APPROVALS	REVISIONS
TEAM LEADER	1 REVISION #1 1/5/06 RELOCATE CABINET, PEDESTAL POLE / ADD APS SIGNALS CJP
ASST. DIV. CHIEF	2 REVISION #2 7/20/06 INSTALL HIB. SIGNAL/REMOVE PONTIUS CT. PED. CROSSING RJM CJS
DIVISION CHIEF	
OFFICE DIRECTOR

MD 80 (FINGERBOARD ROAD) AND SINGLETON DRIVE /PONTIUS COURT

PLAN SHEET

SG-01

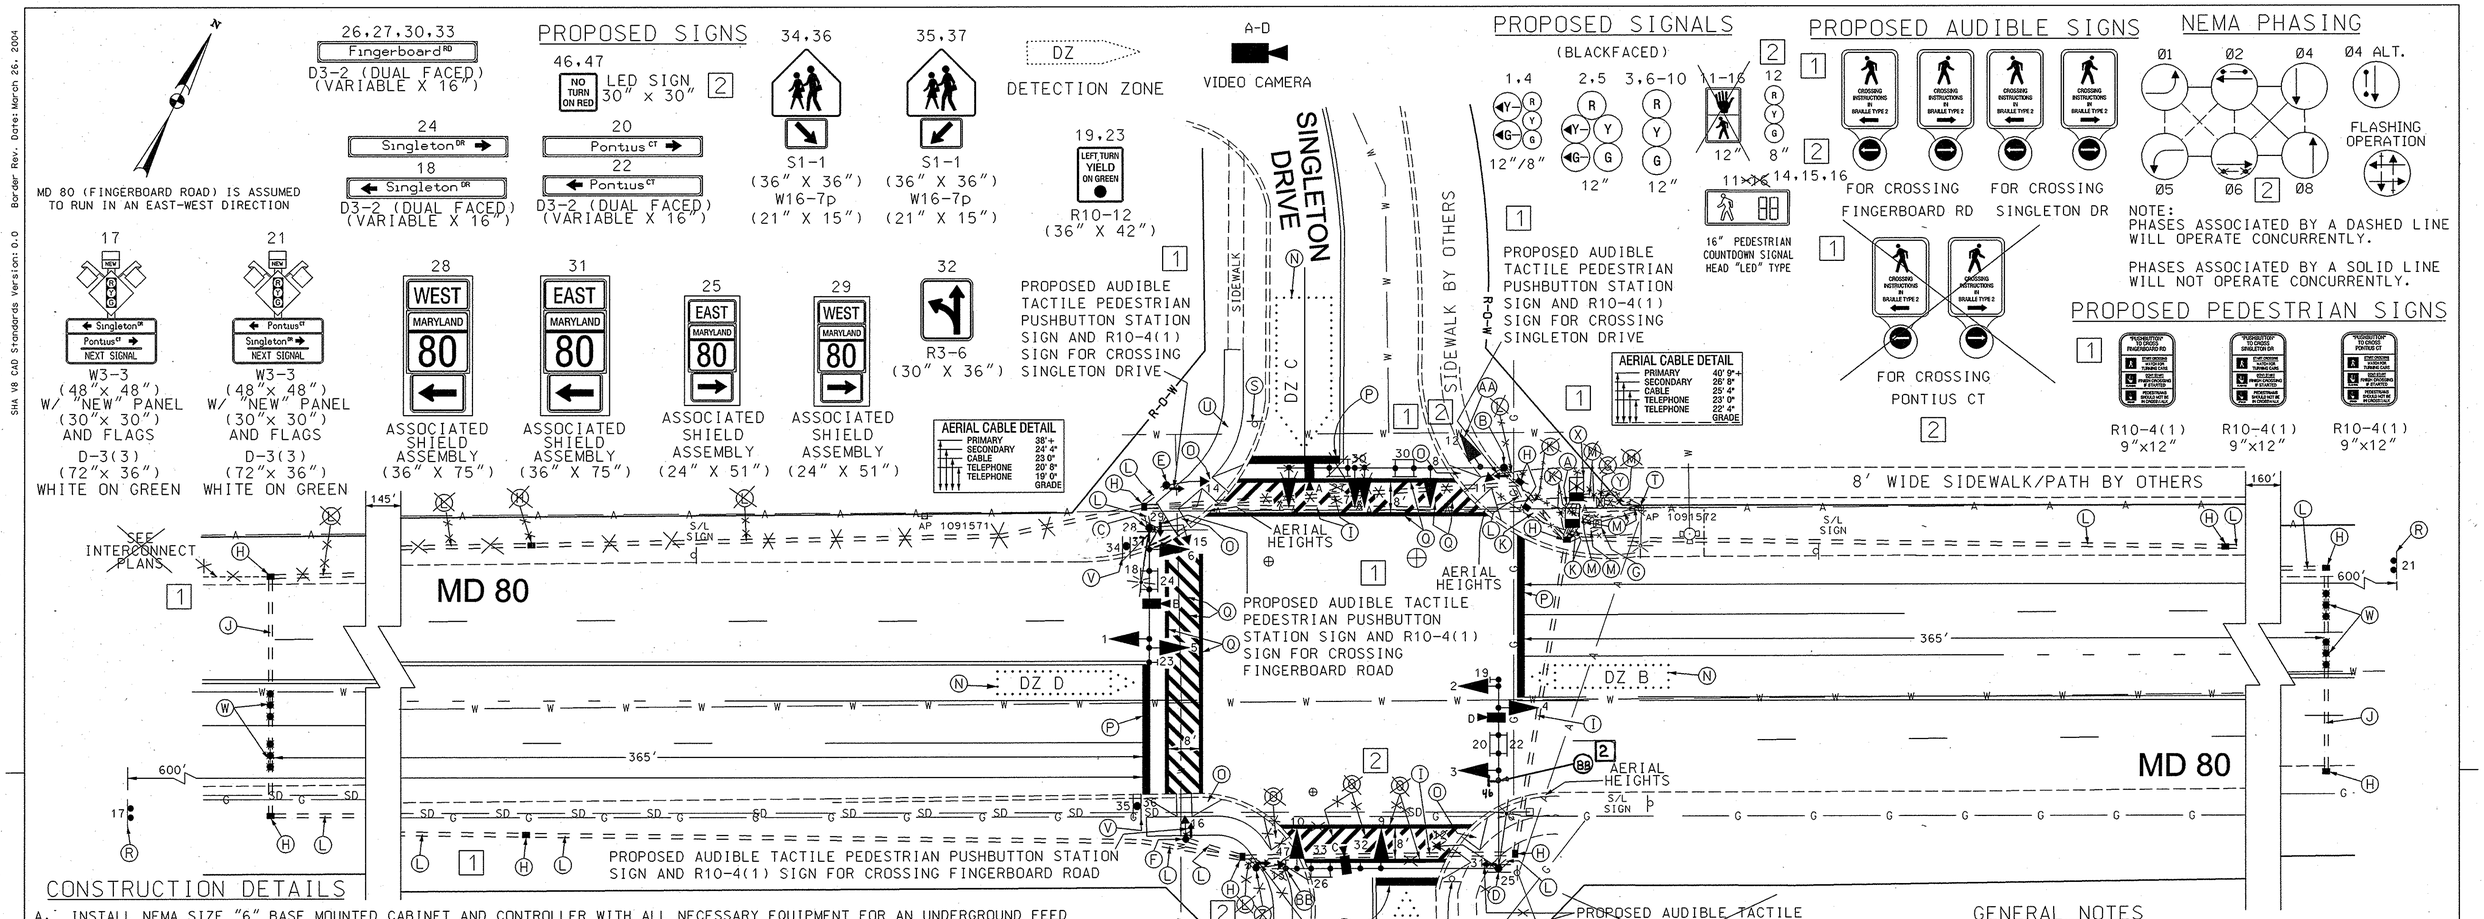
B. INSTALL 21 FT. STEEL POLE WITH 60 FT. MAST ARM, TRAFFIC SIGNAL HEADS, COUNTDOWN PEDESTRIAN SIGNAL HEAD, AUDIBLE TACTILE PEDESTRIAN PUSHBUTTON STATION (SIGN TO READ "PUSHBUTTON TO CROSS SINGLETON DR."), CAMERA, AND SIGNS AS SHOWN (NOTE: 1-3 IN. PVC SCHEDULE 80 CONDUIT BEND). 1

D. INSTALL 27 FT. STEEL POLE WITH TWIN 60 FT. / 50 FT. MAST ARMS, TRAFFIC SIGNAL HEADS, ~~COUNTDOWN PEDESTRIAN SIGNAL HEAD, AUDIBLE TACTILE PEDESTRIAN PUSHBUTTON STATION (SIGN TO READ "PUSHBUTTON TO CROSS PONTIUS CT.").~~ CAMERAS, SIGNS, 20 FT. LIGHTING ARM, AND 250 WATT HPS LAMP AND LUMINAIRE AS SHOWN (NOTE: 1-3 IN. PVC SCHEDULE 80 CONDUIT BEND). 2

P. INSTALL 24 IN. WHITE THERMOPLASTIC PAVEMENT MARKING ~~TAPE~~ FOR STOPLINE.

Q. INSTALL 12 IN. WHITE THERMOPLASTIC PAVEMENT MARKING ~~TAPE~~ FOR CROSSWALK.

W. INSTALL NON-INVASIVE MICRO PROBES. 1

~~Z. INSTALL 10 FT. BREAKAWAY PEDESTAL POLE WITH COUNTDOWN PEDESTRIAN SIGNAL HEAD AND AUDIBLE TACTILE PEDESTRIAN PUSHBUTTON STATION (SIGN TO READ "PUSHBUTTON TO CROSS PONTIUS CT.") (NOTE: 1-3 IN. PVC SCHEDULE 80 CONDUIT BEND).~~ 2
